WCAP-16793-NP, Rev.0 (Non-Proprietary)
Project No. 694

March 2, 2009

OG-09-84

Subject: Pressurized Water Reactor Owners Group
Responses to the NRC Request for Additional Information (RAI) on WCAP-16793-NP, "Evaluation of Long-Term Cooling Considering Particulate, Fibrous and Chemical Debris in the Recirculating Fluid" (PA-SEE-0312)

Figure 15: Integrated Core Flow vs. Core Boil-off for Uniform $C_D = 50,000$ Case

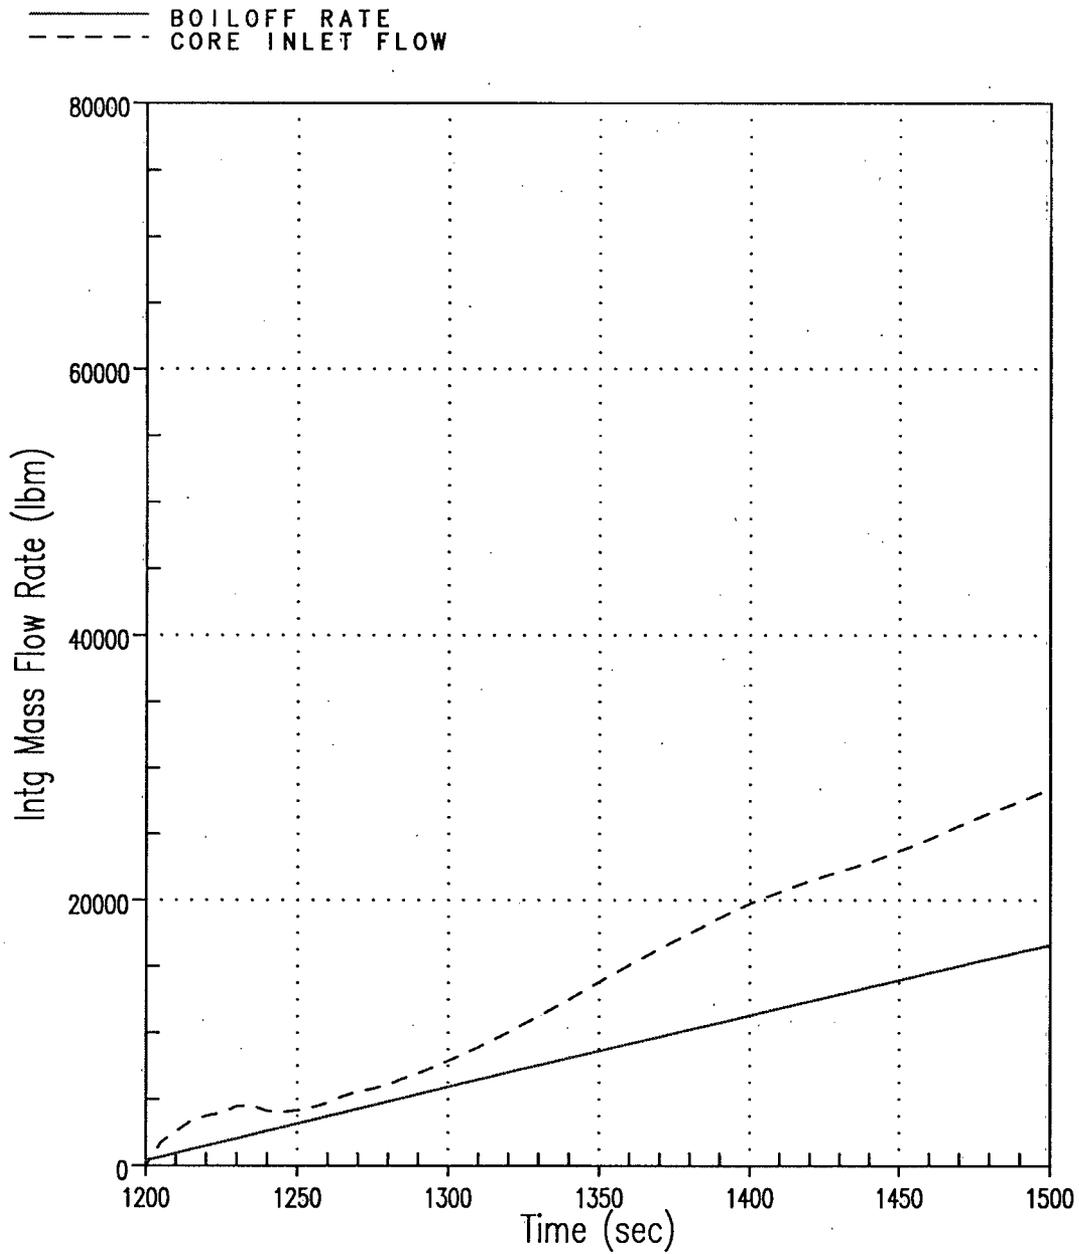
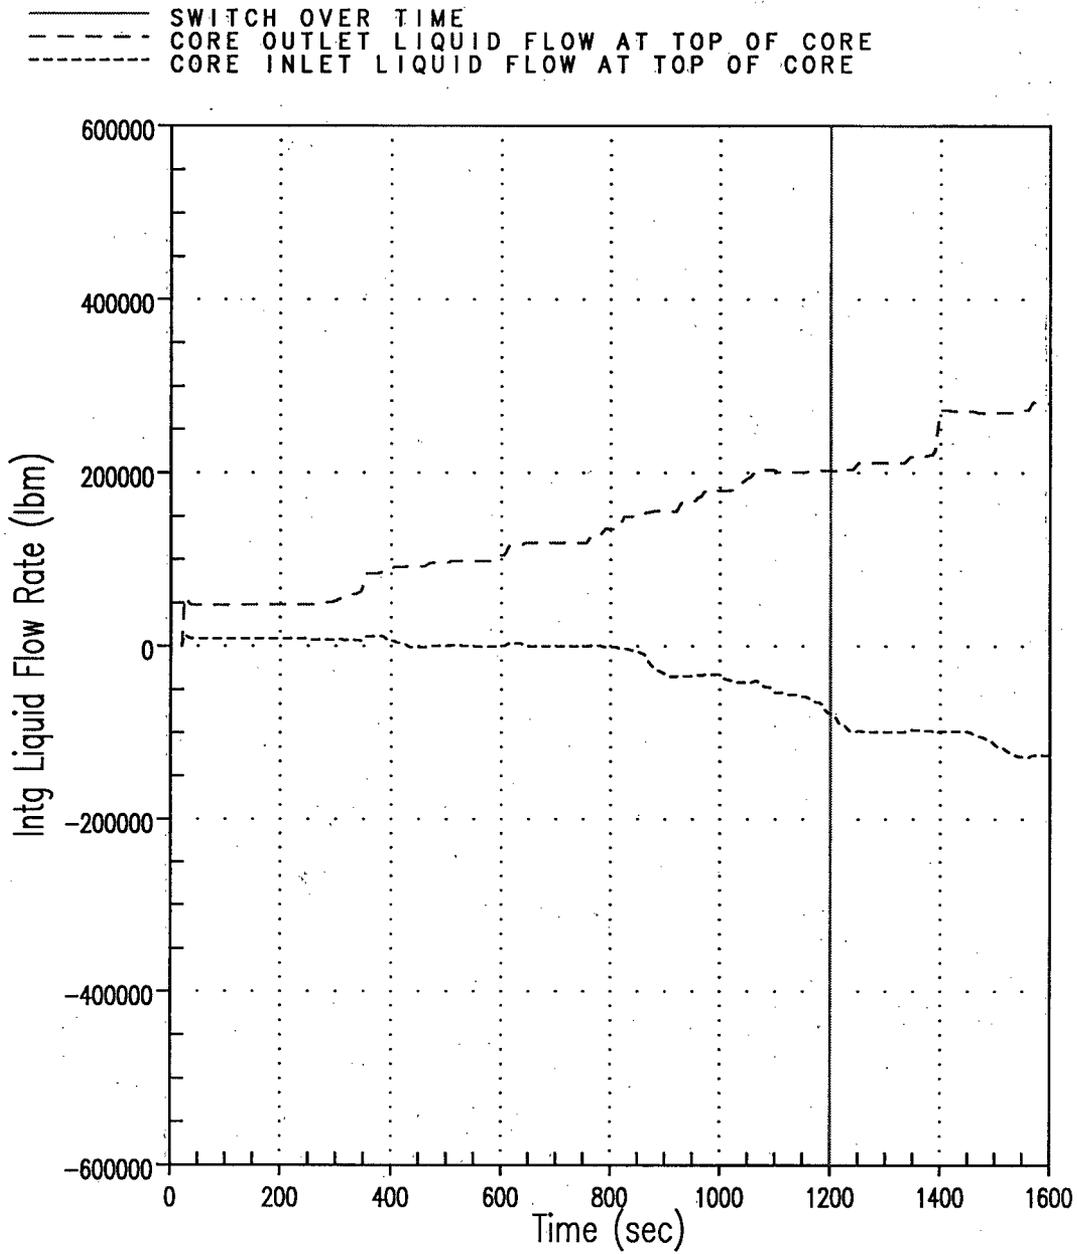
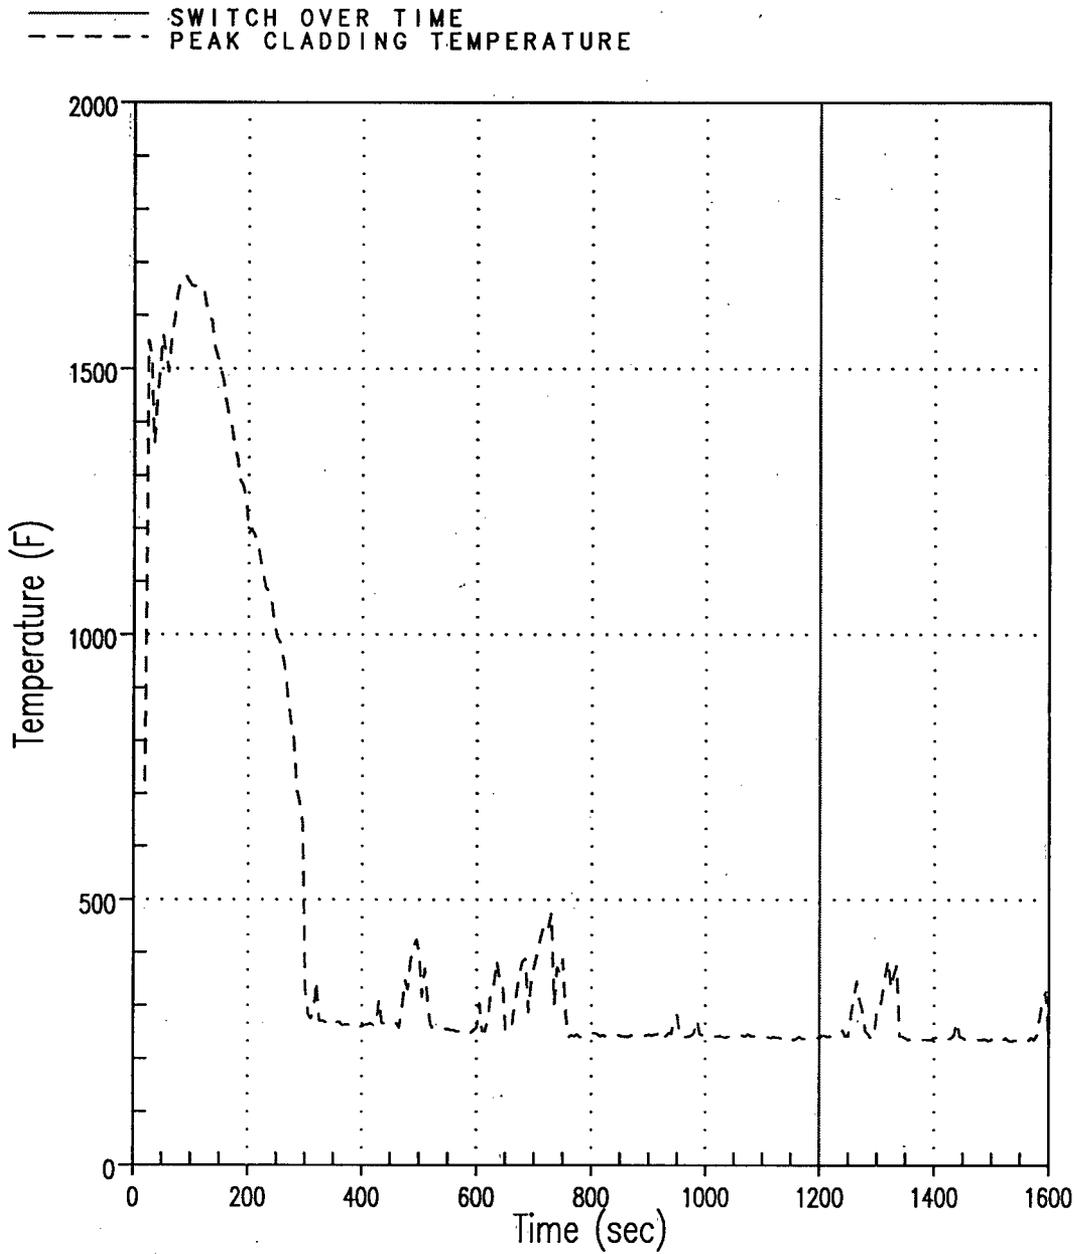
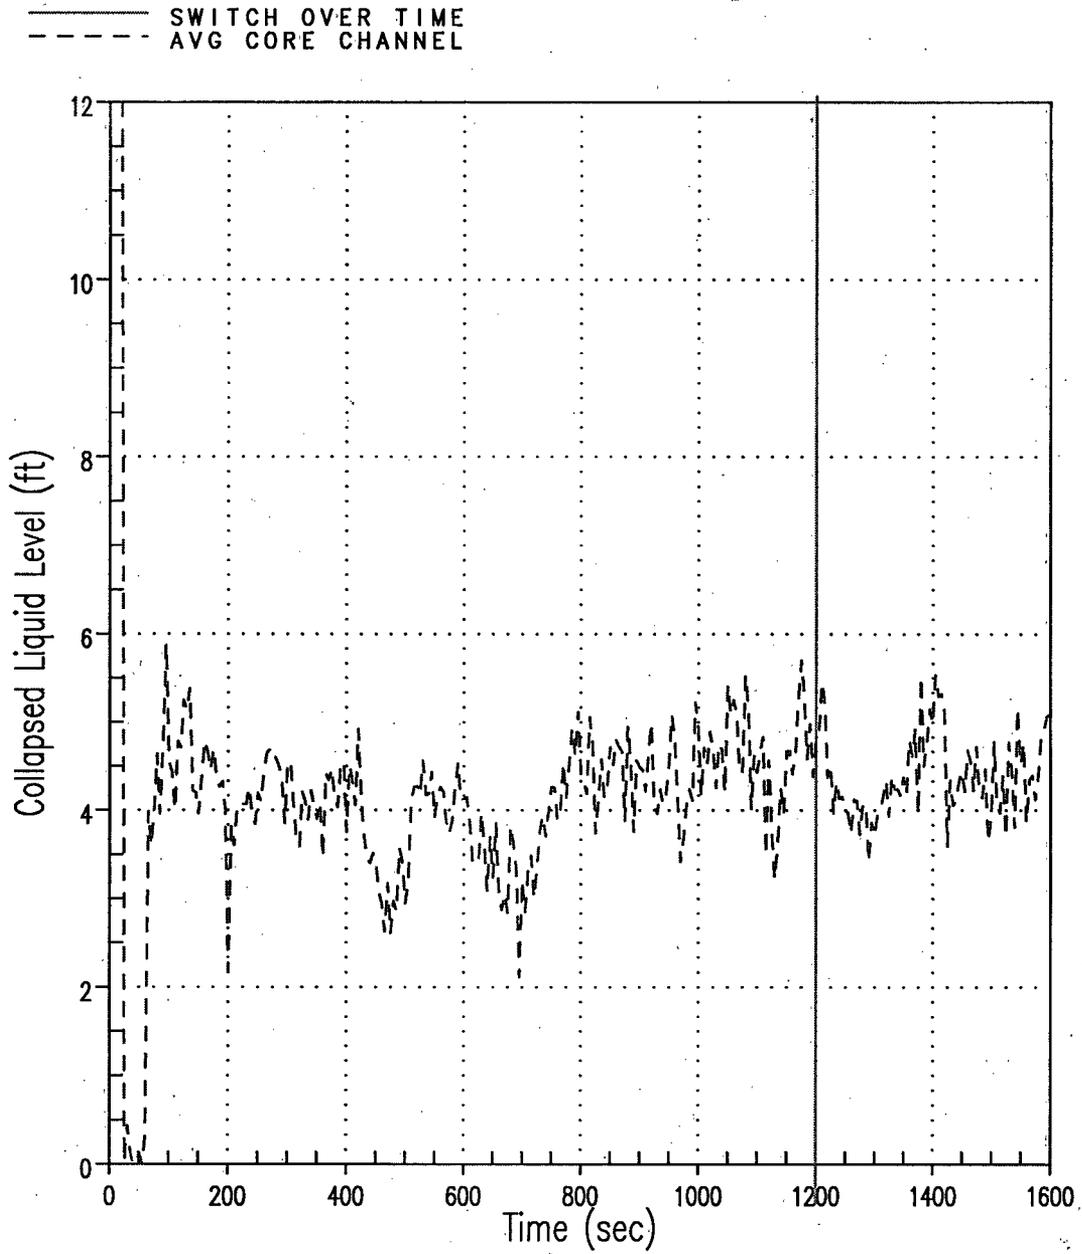
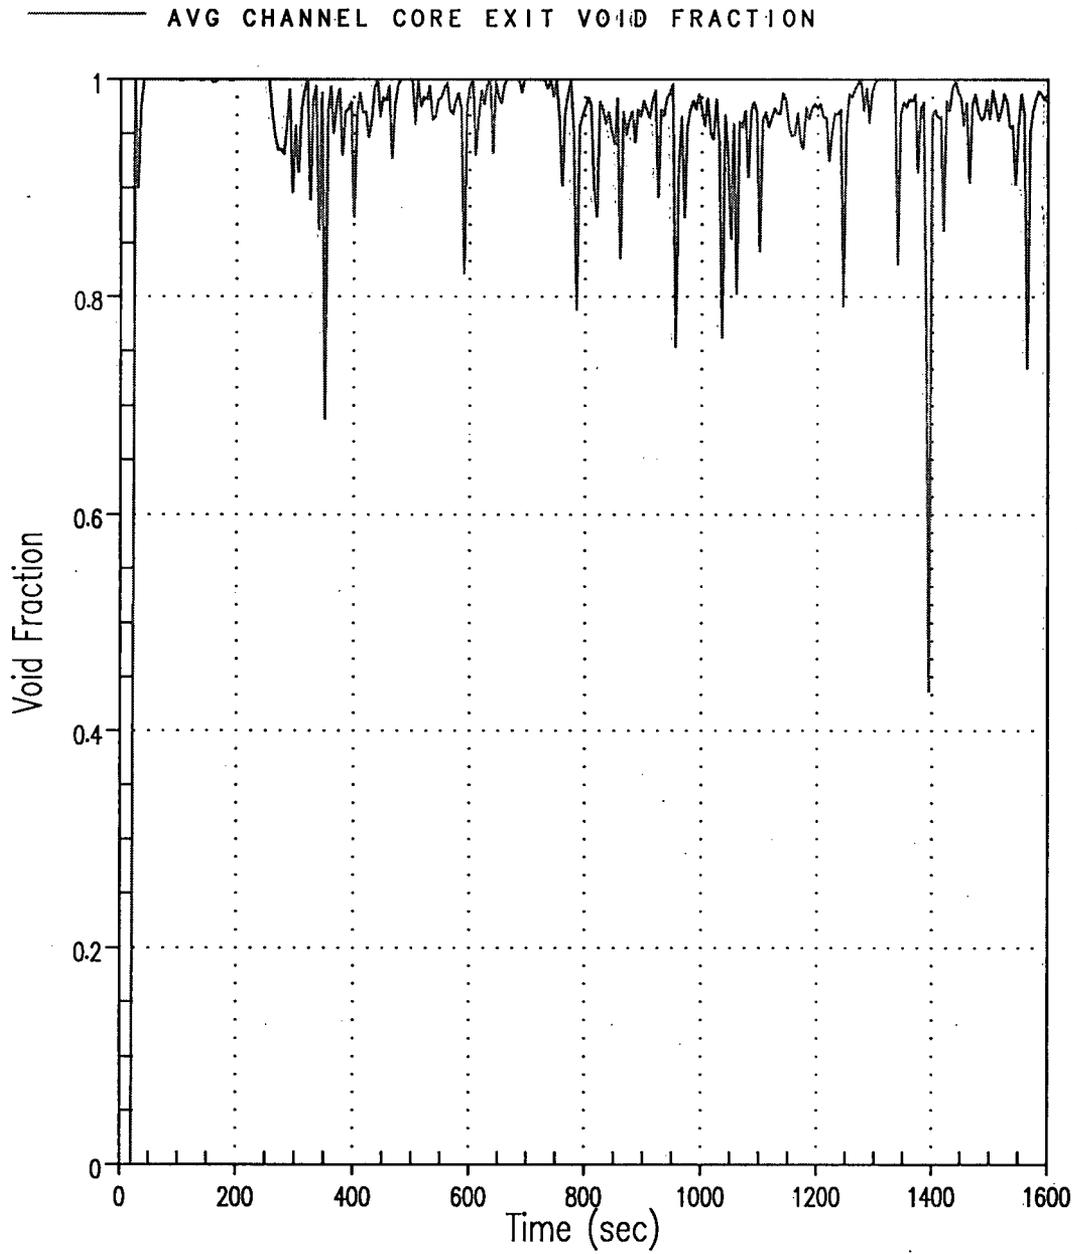
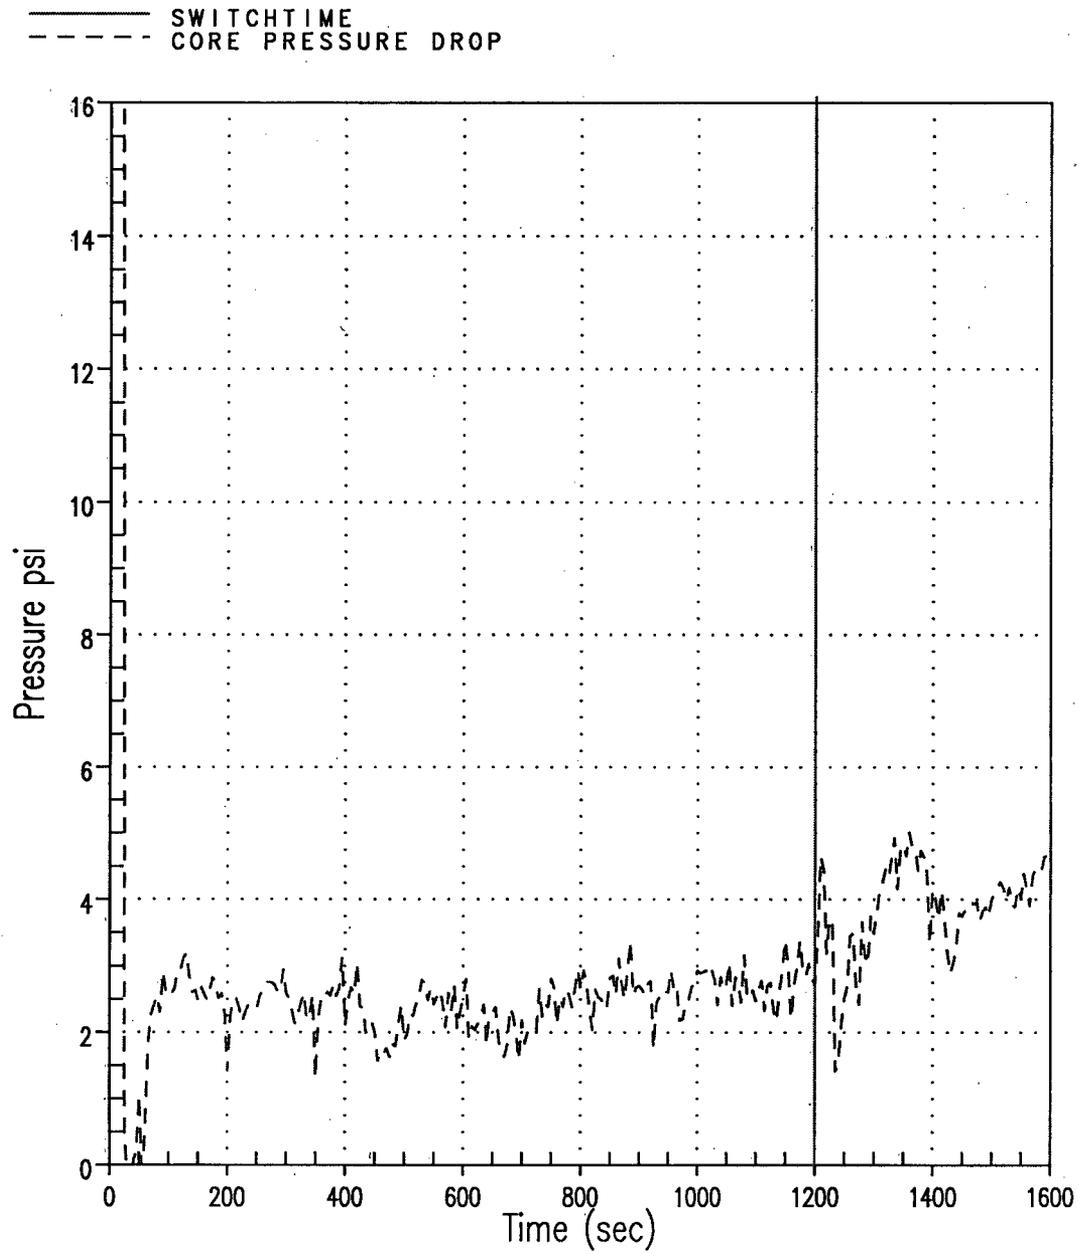
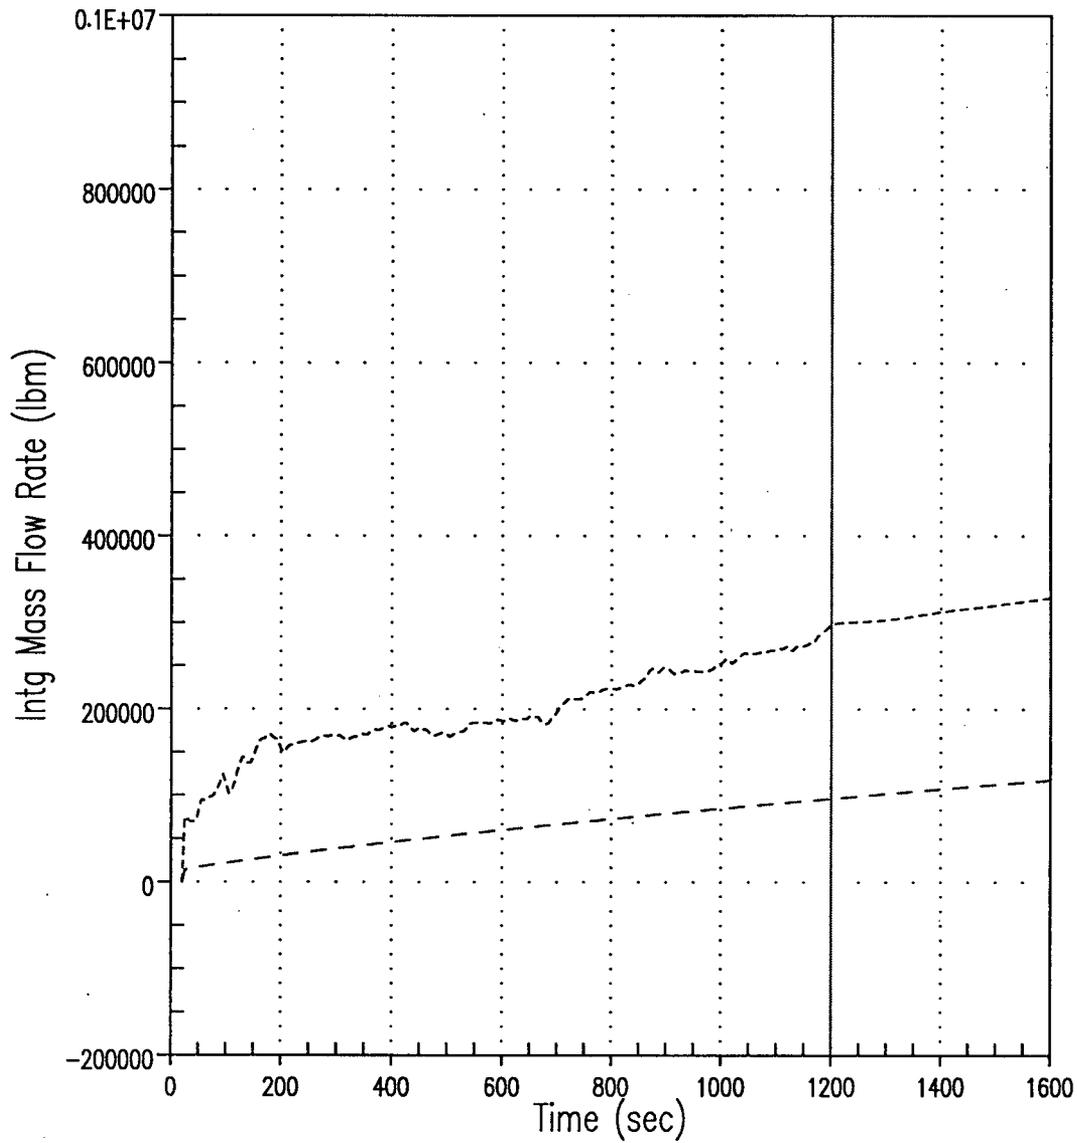
- 1) WCAP-16793-NP, Appendix B, presents analyses of the effect of core inlet blockage using the WCOBRA/TRAC analysis code. Since the report was prepared additional analyses have been performed to determine the blockage level that would reduce core flow below that necessary to match coolant boil-off. Please provide documentation of the additional analyses that have been performed, including figures, for the integrated core inlet and exit flow, peak cladding temperature, core collapsed liquid level, core exit void fraction, and core pressure drop for the bounding conditions. The results should be presented for each case analyzed up to and including the blockage level for which boiloff is no longer satisfied.

The first uniform loss coefficient run performed applied a uniform C_D of 50,000 at the core inlet. The requested plots for this case are shown in Figures 15 through 21. Figures 15 and 16 show comparisons of the integrated core inlet flow and boil-off rate. As shown, even with the increase of the loss coefficient at the inlet, the flow that enters the core is still in excess of the boil-off rate. (Note that the integrated mass flow behavior shown between time $t = 1200$ seconds and time $t = 1250$ seconds of Figure 16 is the result of the 30 second ramp-up of the hydraulic loss coefficient, C_D , to 50,000 that is initiated in the calculations at time $t = 1200$ seconds.) Figure 17 displays the integrated liquid flow at the core exit. The figure displays that liquid in excess of that needed to keep the core quenched enters the core and that liquid flow is present at the top of the core even after the increase of the loss coefficient at the inlet. The PCT is shown in Figure 18. There are no significant PCT excursions after the core inlet loss coefficient is increased. Figure 19 displays the collapsed liquid level of the average assembly core channel (Channel 11 of Figure 6.3.4-3 in Reference 1). The figure shows that the collapsed liquid level drops slightly at time blockage occurs, however, the liquid is maintained even after the increase in the loss coefficient at the inlet. The void fraction at the core exit shown in Figure 20 again illustrates that liquid is present at the top of the core which shows the flow that enters the core after the increase of the loss coefficient occurs is still in excess of the boil-off rate. The core pressure drop is displayed in Figure 21. The figure displays an increased pressure drop of roughly 2 psi as blockage at the core inlet is increased. As the conditions in the Reactor Coolant System (RCS) adjust to increase in core blockage, it is noticed that the core pressure drop fluctuates consistent with the core liquid level.
